ADDENDUM THREE QUESTIONS and ANSWERS

RE: Addendum for Invitation to Bid Number 5815 OF
to be opened April 26, 2018 at 2:00 p.m. Central Time

Questions and Answers

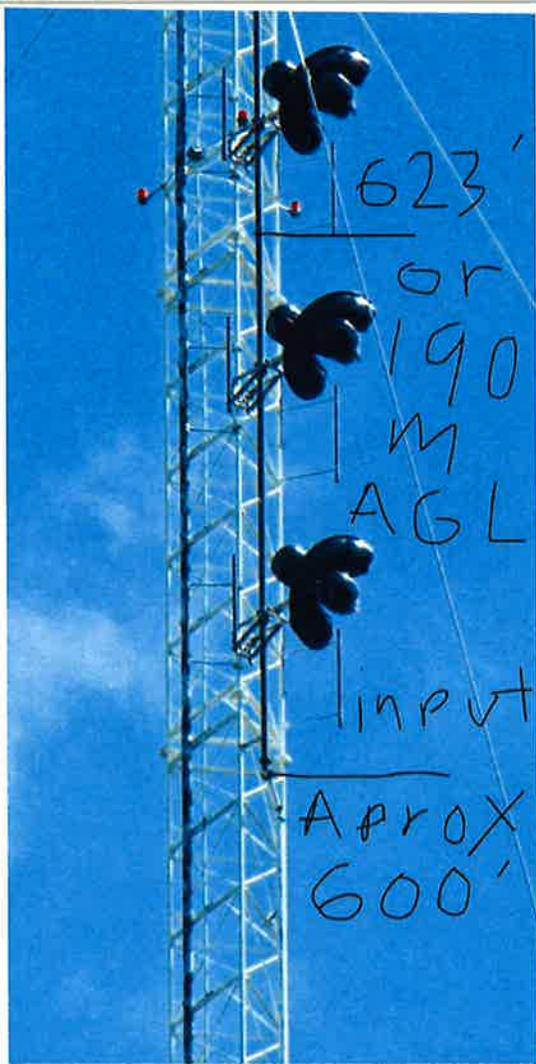
6.			I would like to verify the new transmission line length of 610'. I checked the FCC web site and they have this antenna registered at 190 meters or 623'. I believe that is to the antenna center line from ground level. I estimated the antenna input to be approximately 600' based on a photo I had on file from previous work on this tower. That would allow an extra 10' of coax to get from the tower down the ice bridge to the patch panel or transmitter. In my experience extra coax is also needed for turns/bends along the way. On the positive side you will not need to bring the coax all the way to the ground since the ice bridge and building entry is usually about 10' above ground level. This has probably all been factored in already, but I thought it may be worth mentioning. Please see attached photo.	Please refer to answer for question #1.
